**Attachment 4: Replacement Pages of Sewerage Impact
Assessment**

Title PROPOSED SEWAGE DISPOSAL SCHEME	Project title LAYOUT PLAN SUBMISSION AND PROPOSED MINOR RELAXATION OF BUILDING HEIGHT RESTRICTION FOR PERMITTED FLAT USE AT 131 POK FU LAM ROAD, HONG KONG, RBL 136RP	Figure no. LILY16/SIA/002	
	 BINNIES HONG KONG LIMITED 賓尼士工程顧問有限公司	Prepared -	Checked -
		Date 06/24	Scale A3 1:500

Layout Plan Submission and Proposed Minor Relaxation of Building Height Restriction for Permitted Flat Use At 131 Pok Fu Lam Road, Hong Kong, RBL 136RP

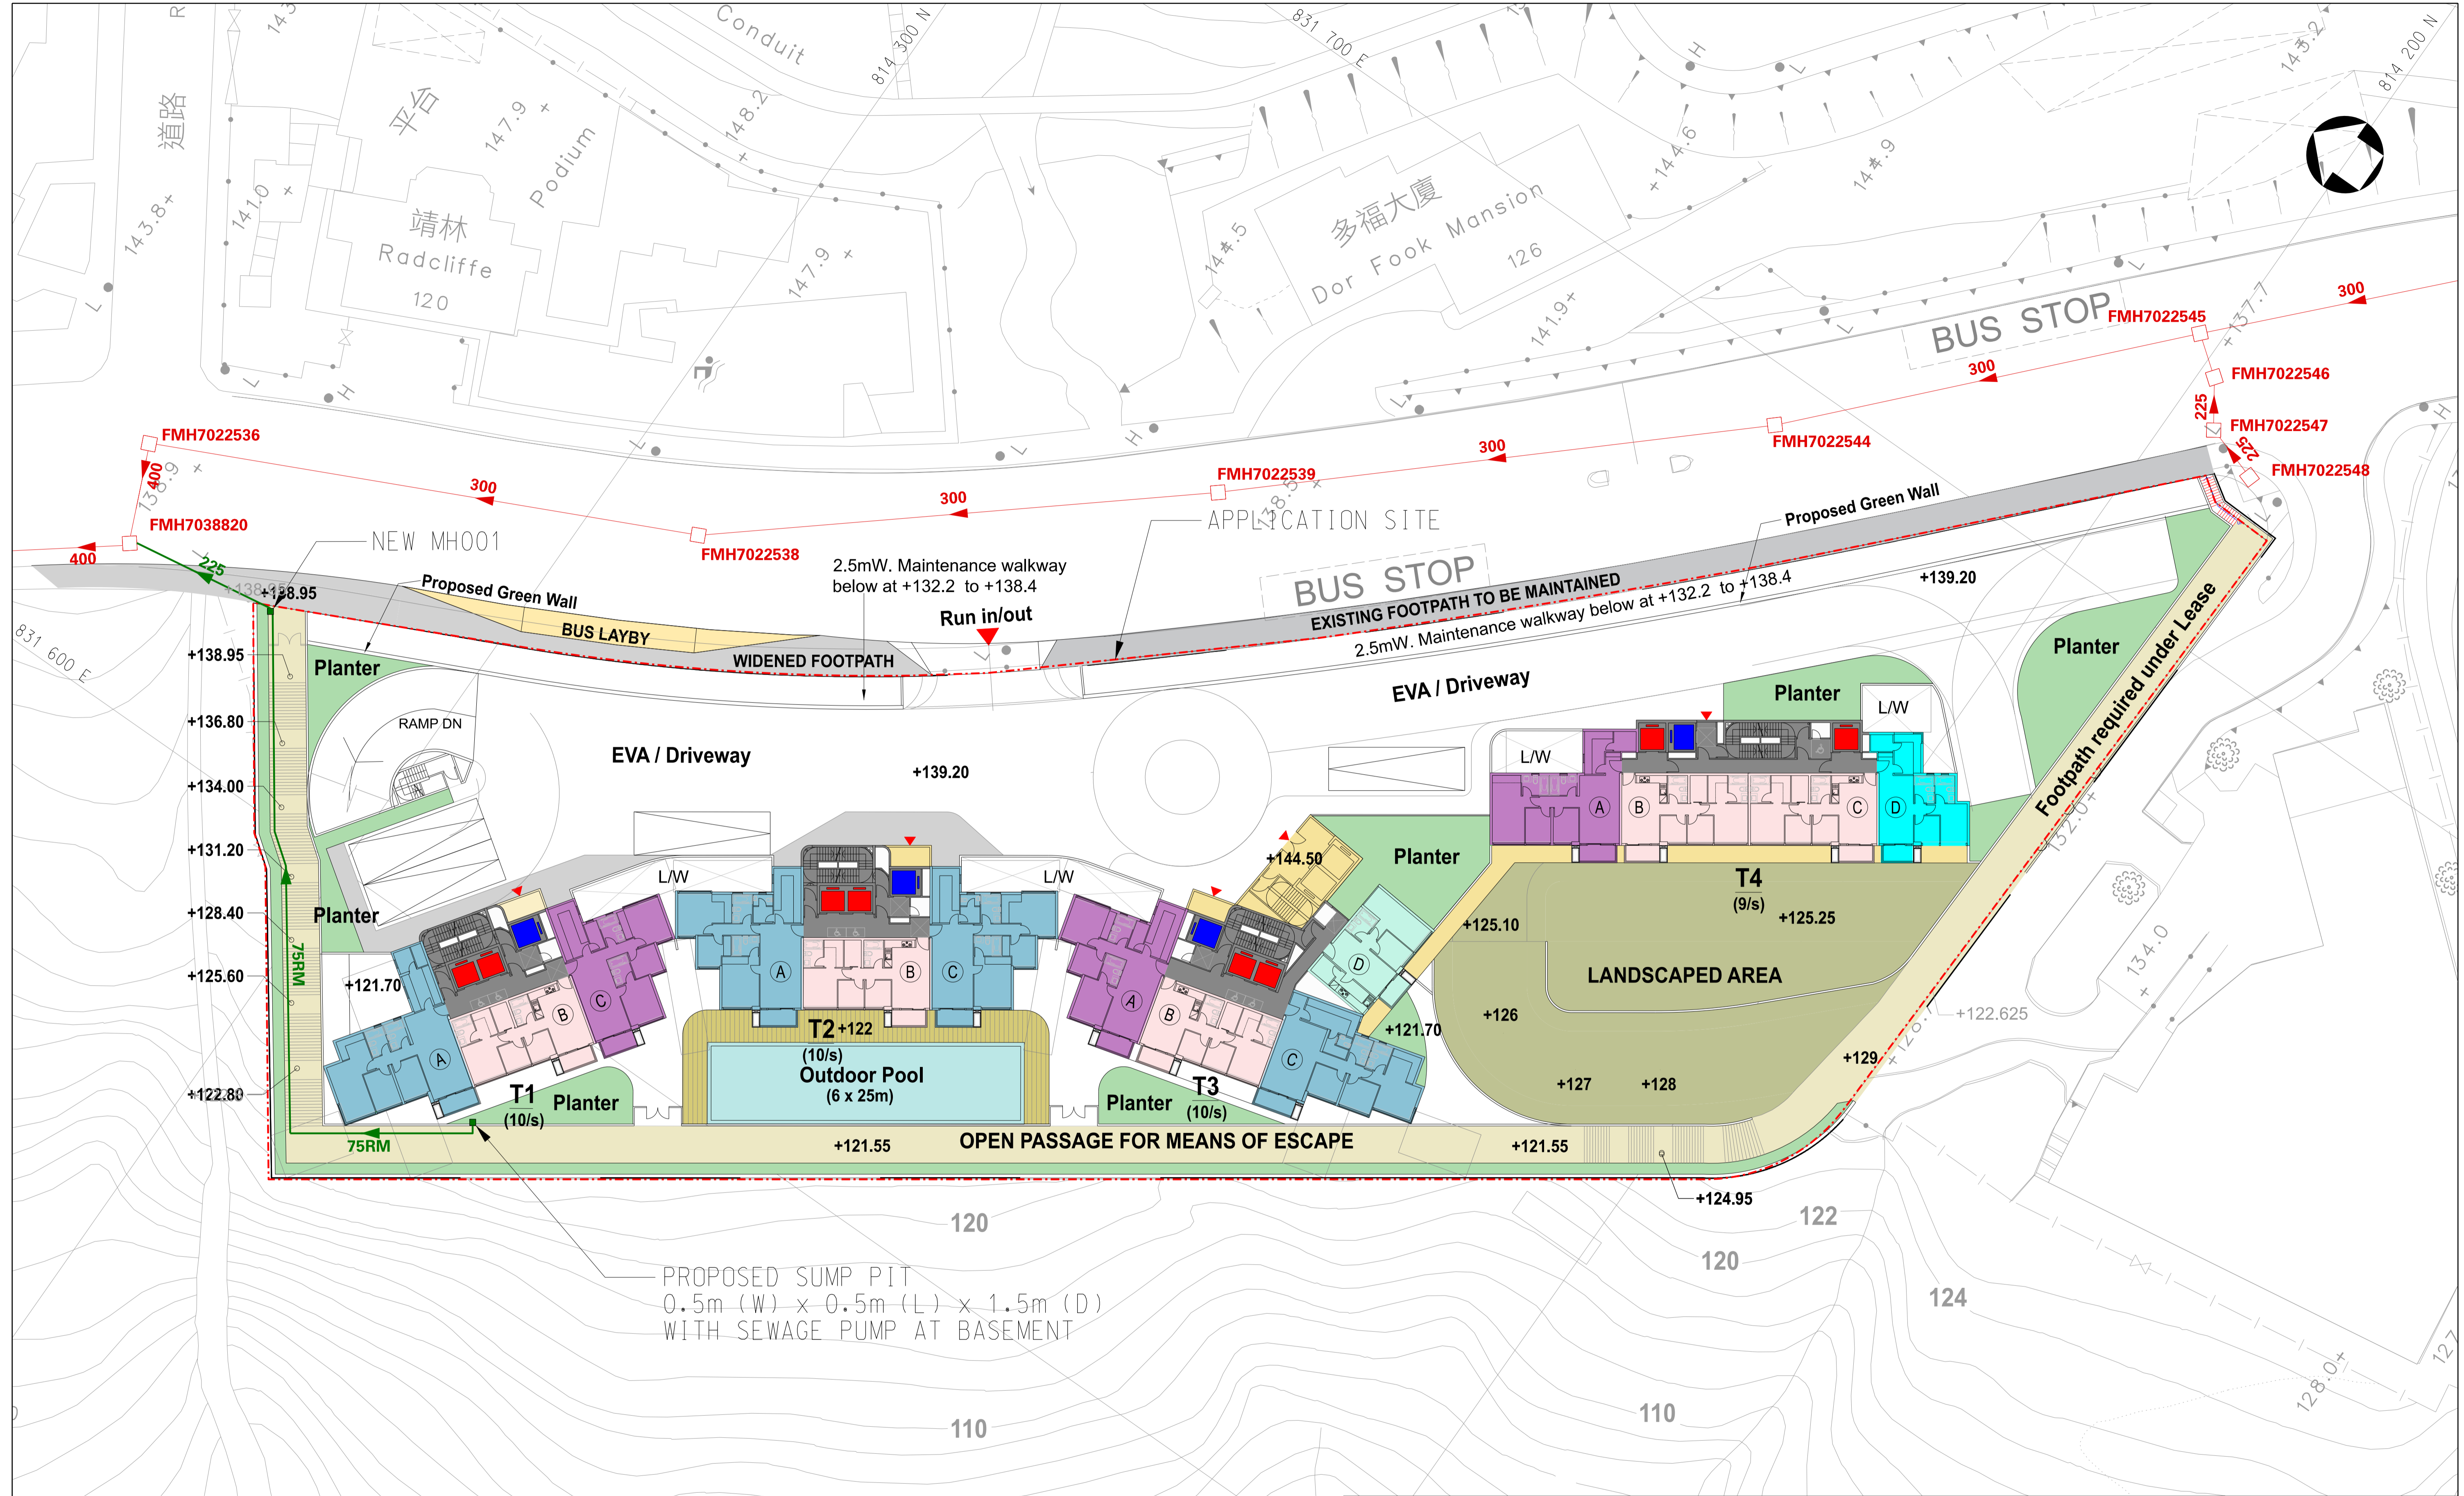
- 4.4 To minimize the impact to the public sewer, the sewage generated from the Proposed Development will be discharged to further downstream (manhole no. FMH7038820), which has spare capacity (Current utilization is approximately 39 %).

- 4.5 As the proposed formation level of the Application Site (approximately +120 mPD) is located below the level of the existing public sewerage system at Pok Fu Lam Road. A sump pit (with size 0.5m x 1m x 1.5m) and sewage pump (with pump rate of 24,804 l/h or 0.00689 m³/s) are proposed to pump the sewage generated from the Proposed Development to a new manhole (MH001) and further discharge to manhole no. FMH7038820 via a new 225 mm dia. sewer. **Drawing No. LILY16/SIA/002** shows the proposed sewage disposal scheme. The estimation of proposed sewage flows at Pok Fu Lam Road as well as calculation of sump pit size and sewer size is enclosed in **Appendix B**.
